Appl. No. 09/804,022
Amdt. Dated October 4, 2004
Reply to Office Action of July 20, 2004

REMARKS

FIG. 1 (Prior Art)

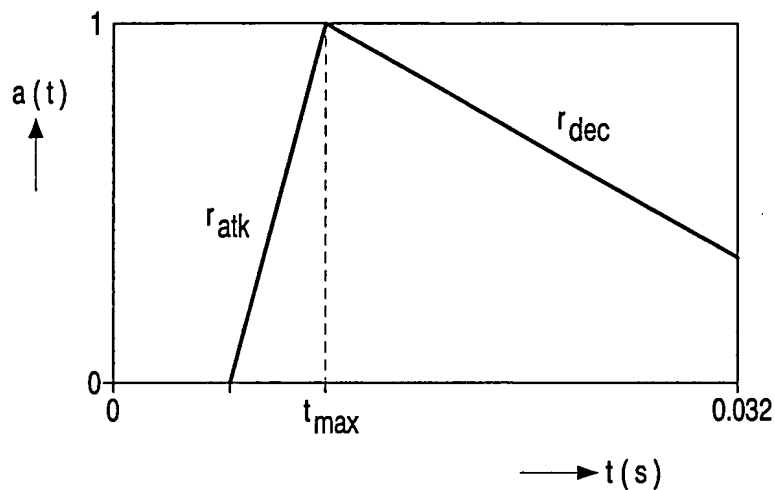
The Examiner also objected to the drawings with regard to Figure 1, indicating that there should be a designation included by a legend such as - - Prior Art - -. Applicants have
20 corrected the drawing sheet for Figure 1 by including the label "Replacement Sheet" in the page header, and by including in parenthesis to right of "FIG. 1" the legend - - (Prior Art) --.
